NISTUNE TECHNICAL BULLETIN #002

TITLE : Correction of ECU Air Flow Meter modifications

Models covered: HR31, RB20DET, CR31 RB30E, VLT RB30ET, Z31 VG30E/ET (1986-1987)

Date: 25 September 2009

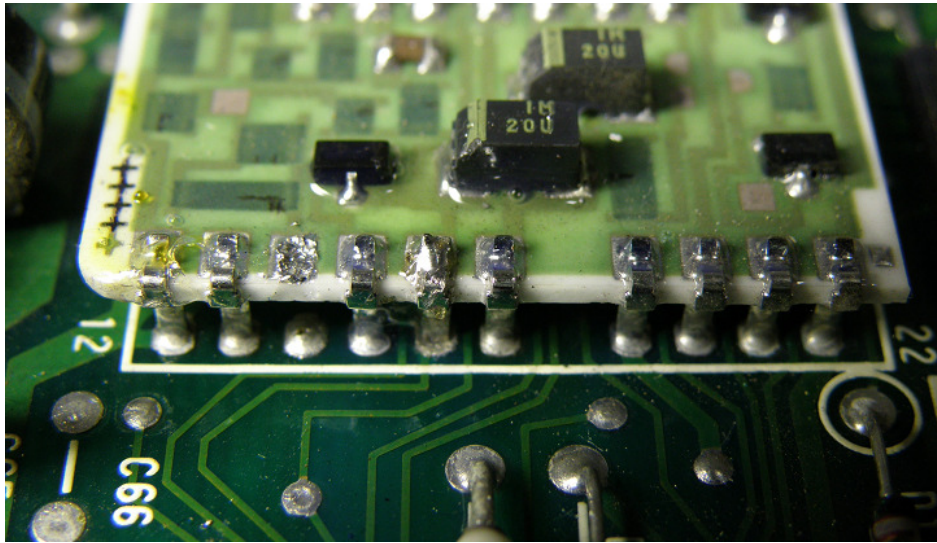
Following this modification it has been noticed during field testing that logs have indicated that 0 and 5 volt spikes in the AFM signal received by the HD46510 chip have been received and processed as can be seen below:

The removal of the opamp from the circuit has affected filtering of the ECU and occasional spikes in the fuel injection could be potentially noticed. In the log above TP was not affected, so the map points accessed were not changed.

One of our forum members has been researching the circuitry further investigating an alternative solution. He has found that by removing an 8 volt input signal from the opamp negative input that the existing circuitry can still be used without the original 1.5 volt drop.

What this means is that there is a simpler and better solution to the previous document AFM modification for these ECUs.

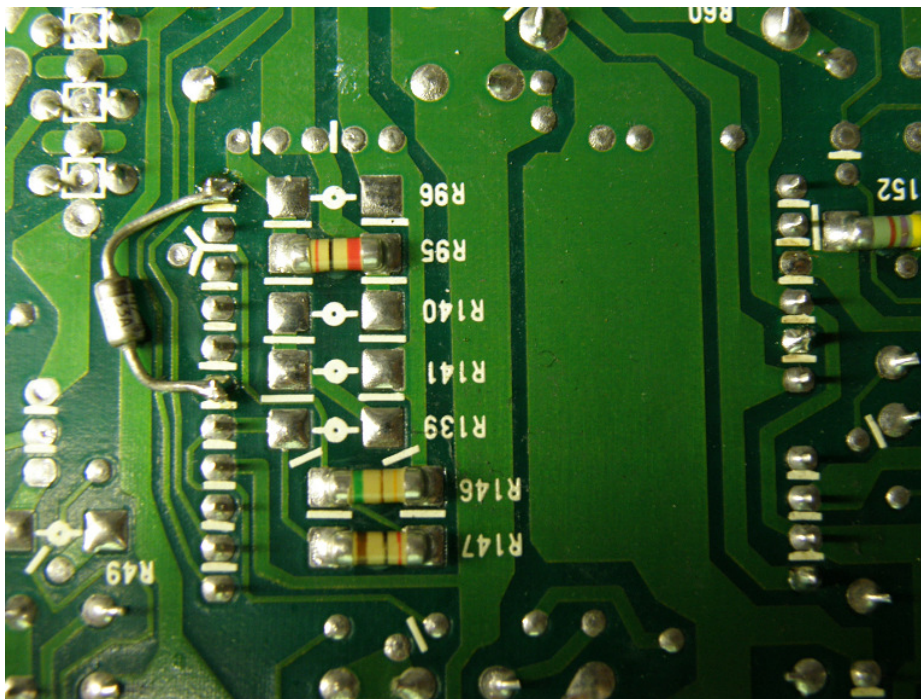
1. Remove pin 14 from the omp amp board (this is two pins up from pin 12 marked at the end)

2. Using a zener diode is still recommended as the opamp may not protect against over voltage from the AFM if it occurs. It will need to be moved to the input side of the ECU

Solder the banded end of the zener diode to pin 11, and the other end to pin 6 as pictured below.

3. Reinstall the ECU and as a test you can measure pin 11 and pin 16 with a voltage meter against ground to check they measure approximately the same voltage.

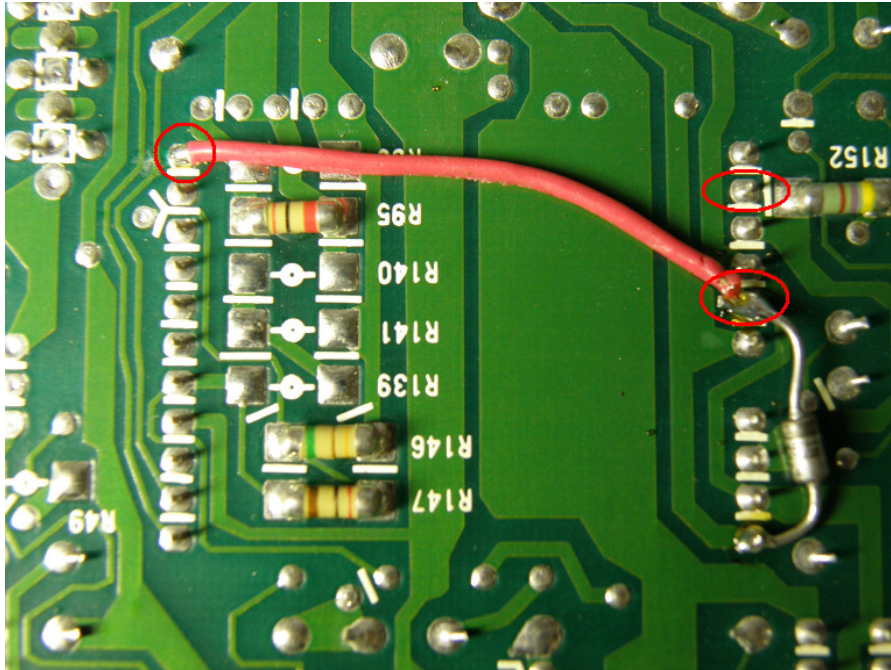
1. On the reverse side of the ECU desolder and remove the installed wire jumper and zener diode
2. Desolder the holes which are highlighted by the red circles in the diagram

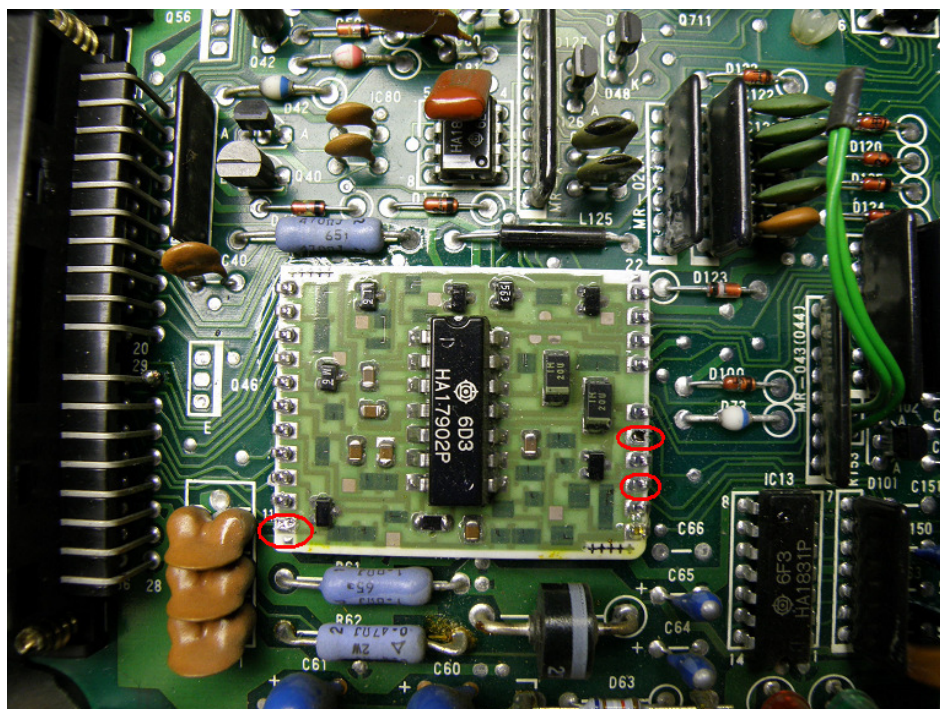
3. Remove Pin 14 (lower RHS) from the board and move to previously removed Pin 16 (upper RHS) and solder in. Reinstall Pin 11 (lower LHS) to the board using jumper wire or similar.

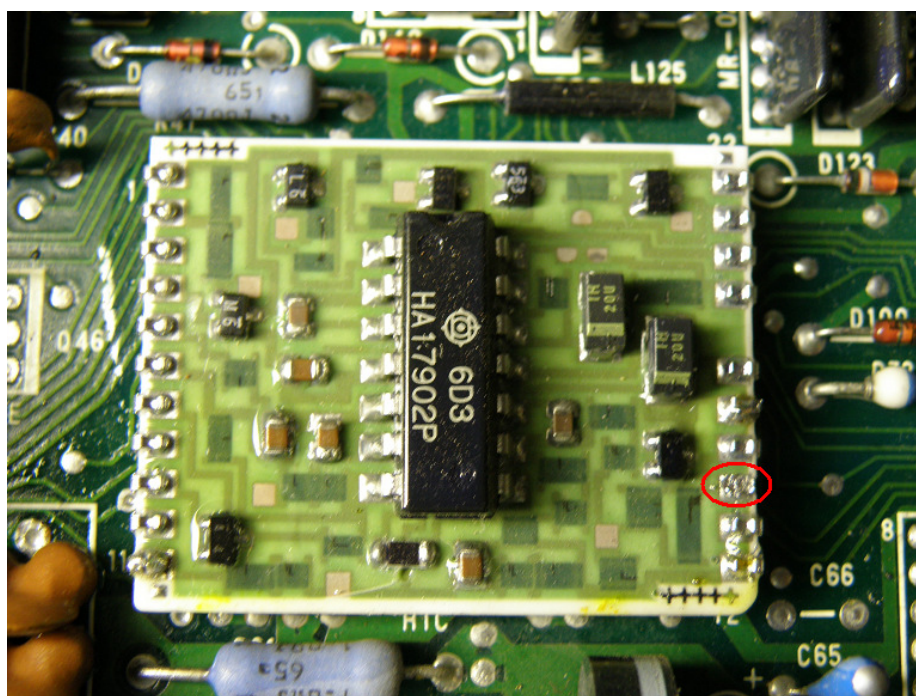
4. Now the circuit board should look like the picture below. Both pin 11 and pin 16 have been resoldered and pin 14 (highlighted) is now removed

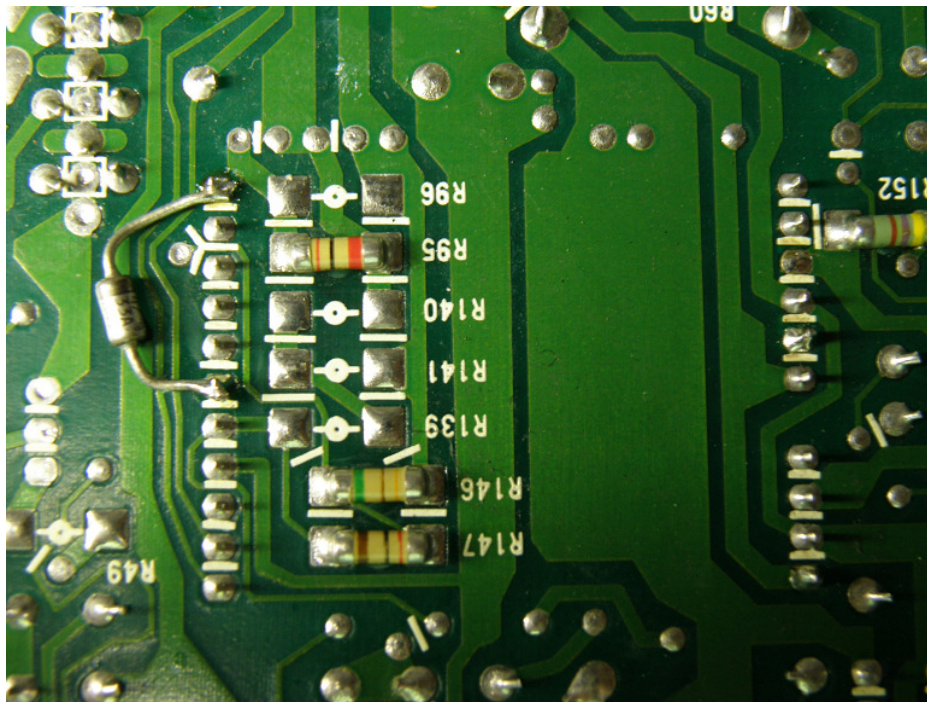
5. Retaining the zener diode is still recommended, as the opamp may not protect against over voltage from the AFM if it occurs. It will need to be moved to the input side of the ECU

Solder the banded end of the zener diode to pin 11, and the other end to pin 6 as pictured below.

6. Reinstall the ECU and as a test you can measure pin 11 and pin 16 with a voltage meter against ground to check they measure approximately the same voltage.

Modification Required for HR31 RB20DET ECUs

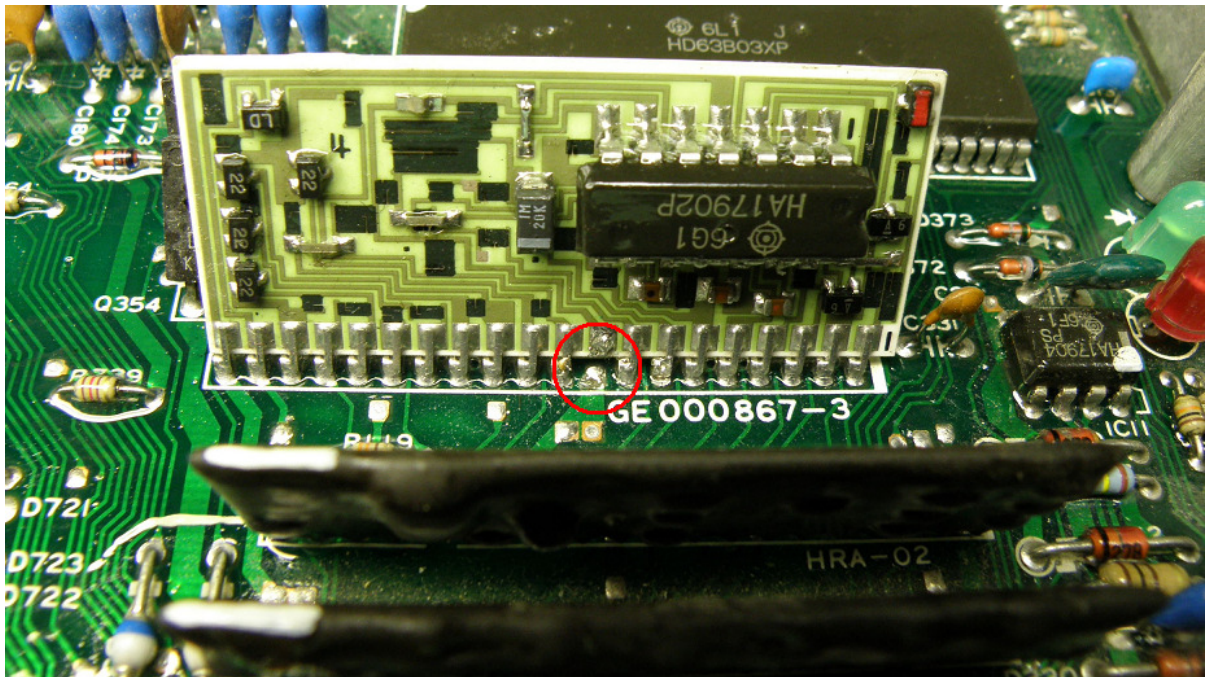
1. Locate opamp daughter board

2. Remove pin 9 from the board to the ECU. This is the voltage line to the opamp. Do this by removing solder on the reverse side using a desoldering gun and then heading the front side with a soldering iron and prying away with a small screwdriver or tweezers.
3. Connect a 5.1 volt zener diode with stripe side on pin 8 and other end on pin 6 (ground) as pictured below. *Note: There is no longer a solder join between pins due to the removal of pin 9*
